M E M O R A N D U M

TO: Casey Adragna, Adragna Architecture
FROM: Elizabeth Steward, Associate Planner- Development Review
DATE: 6/18/26
SUBJECT: Douglas 234 Multitenant, Site Plan
Review Comments 04

LOT 10B, DOUGLAS 234 FILING NO. 6, AMENDMENT 2
HORSE CREEK COMMERCIAL SITE PLAN
LOCATED IN THE SW 1/4, SE 1/4, SECTION 29, T6S, R66W, 6TH P.M.
TOWN OF PARKER, COUNTY OF DOUGLAS, STATE OF COLORADO
PAGE 1 OF 15

FIRST FLOOR PLANS
DOUGAS 234 FILING NO. 6, AMD. 2
DATE: JUNE 8, 2026

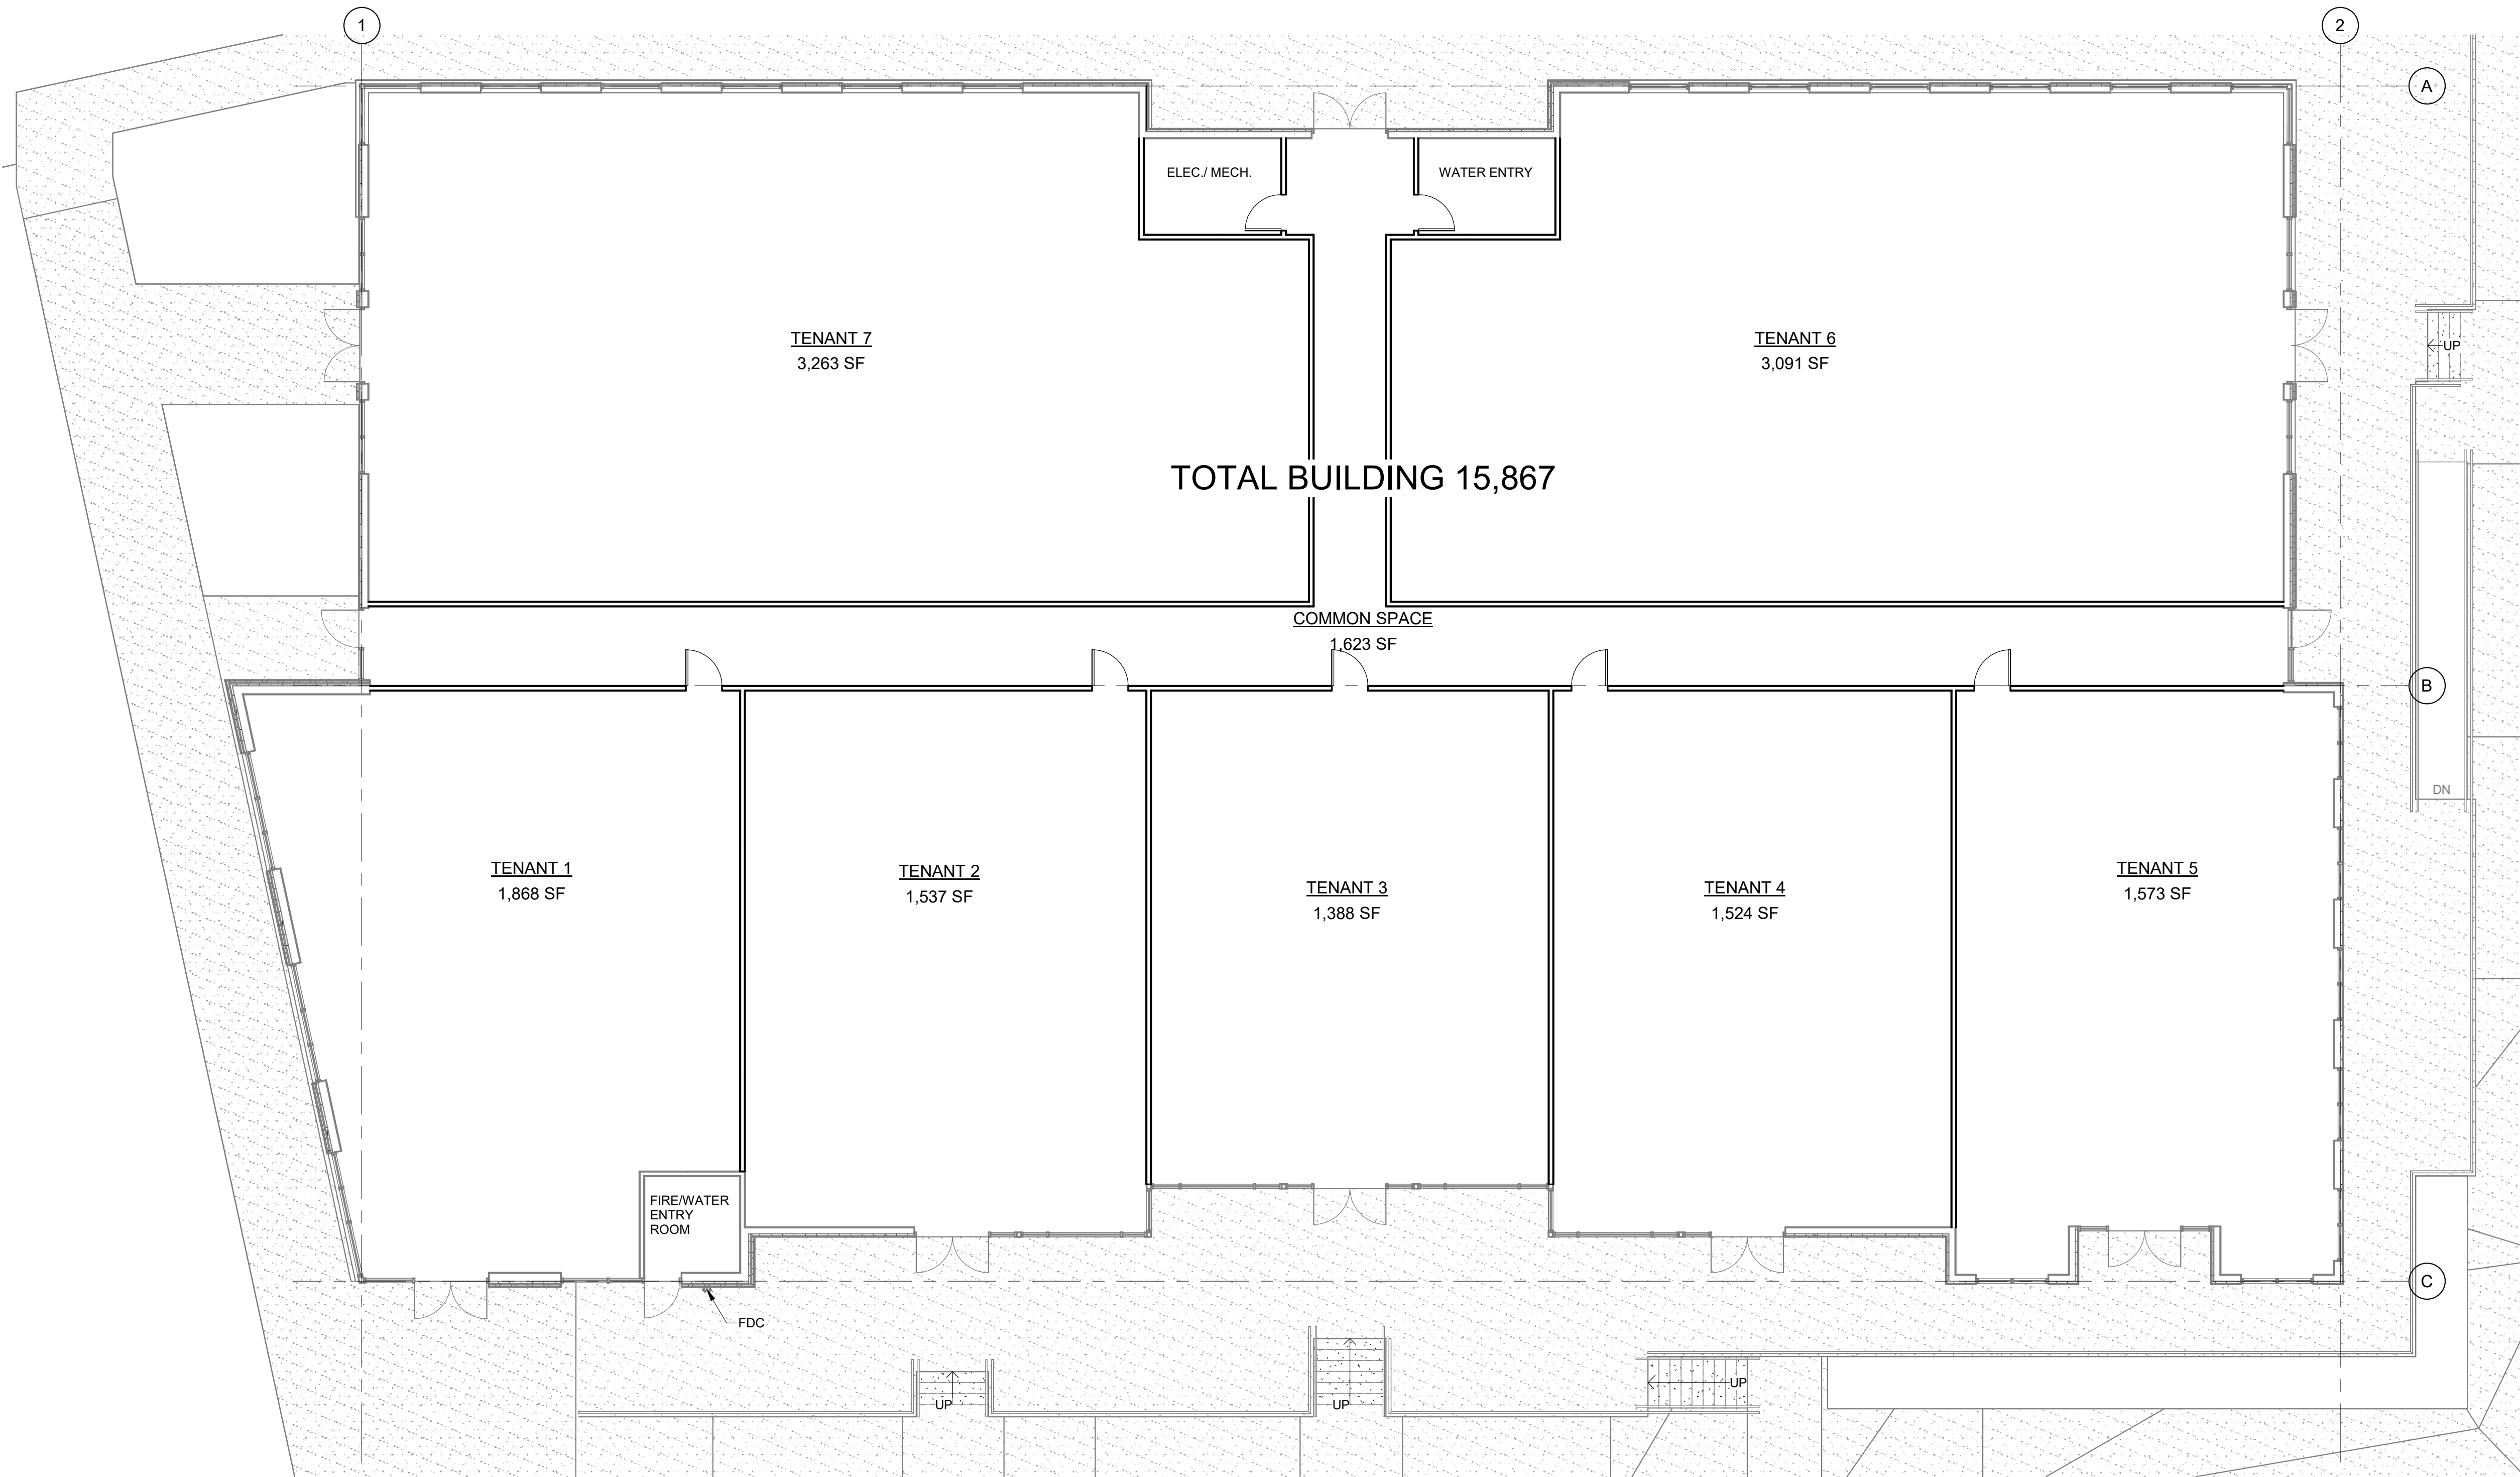
4. Has a proposed address already been assigned for the building from Douglas County Addressing? I do not see it in my files, if not, please let me know and I can request the building proposed address.

Do you know if the previous planner sent out for a building address/ let you know of a proposed address? If not, please let me know and we will get that handled in the next review cycle.
